D/DRC Case

3326 Kline Street

DESIGN/DEVELOPMENT REVIEW COMMISSION
DESIGN REVIEW DISTRICT
HISTORIC AGENDA
EVALUATION SHEET
Case # 3

NATURE OF REQUEST: Request Certificate of Design Approval for addition

Location of addition

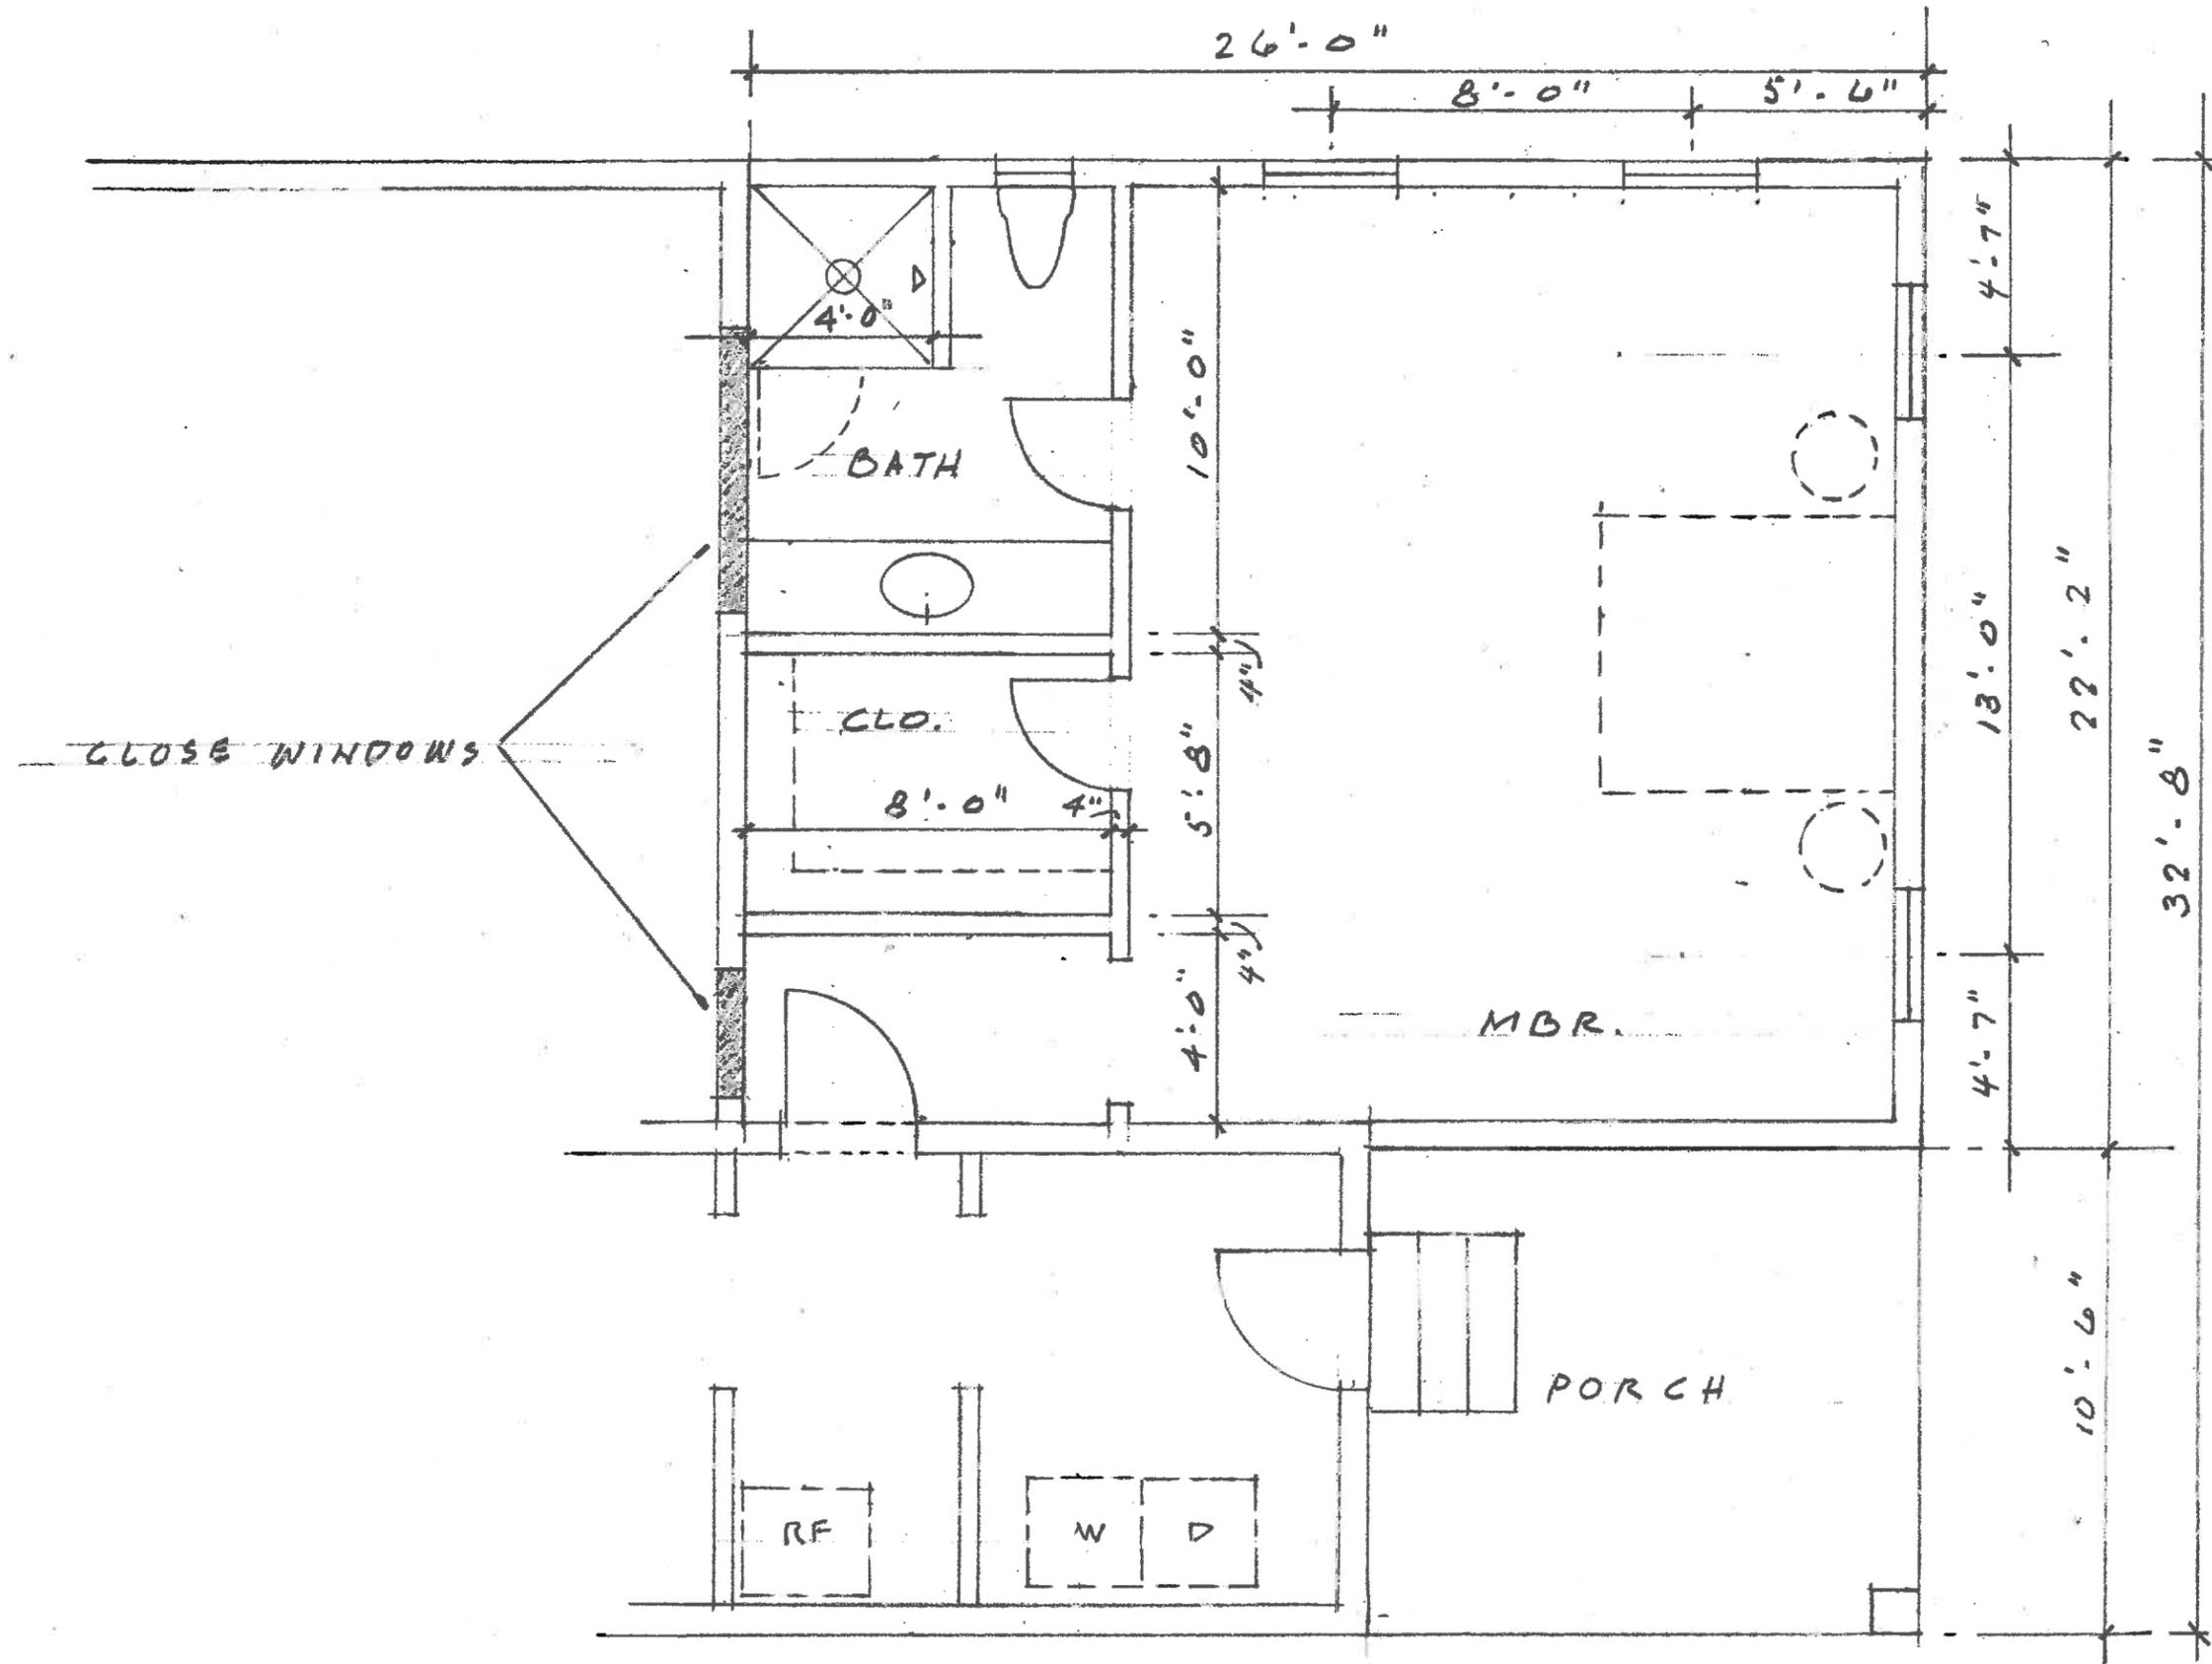
At Right: Addition will be in the back yard shown at right, the foliage will likely be cleared out and the brick wall removed.

1/4" - FLOOR PLAN - HENDRICKS RESIDENCE - 3326 KLINE ST.

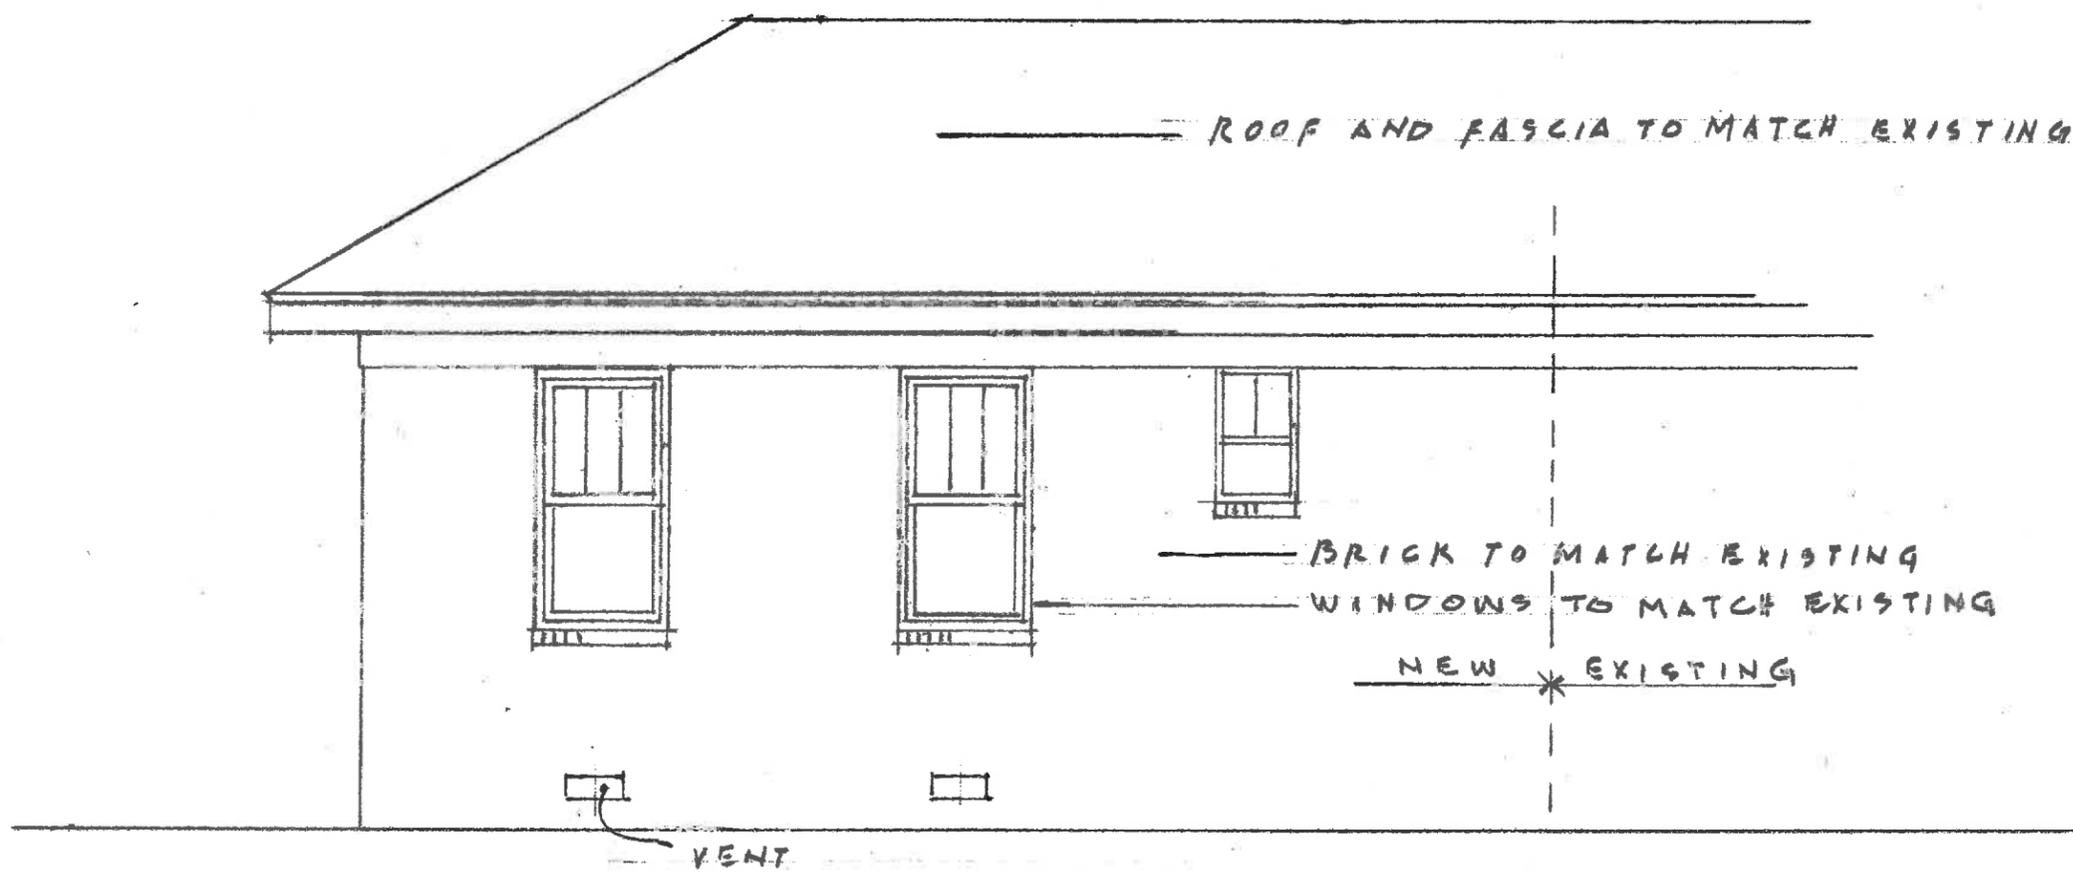
The massing is compatible with the building. The side elevation is broken up into three bays by three windows, and the rear elevation has two windows to break up the rear wall. An inset porch in the addition on the rear corner away from the street also breaks up the massing.

Windows: The proposed windows are vinyl with grids between the glass. Vinyl windows do not successfully replicate the visual characteristics of historic, true-divided light, single-pane wood windows. They fail to replicate dimensions and detailing, and usually do not match important characteristics such as muntin widths, and the widths of rails and stiles. In this instance, the grids between the glass do not replicate the exterior muntins of historic windows, and the proposed windows have a 7/8" muntin, which is wider than the typical 5/8" wide muntins. The proposed windows do not meet the guideline. Wood or aluminum-clad wood windows would be recommended instead as they can successfully replicate historic windows in many cases.

- The windows in the addition be wood or aluminum-clad wood that replicates the 3/1 window pattern originally on the house, has exterior muntins, and matches the details and designs of the original windows
- All details deferred to staff
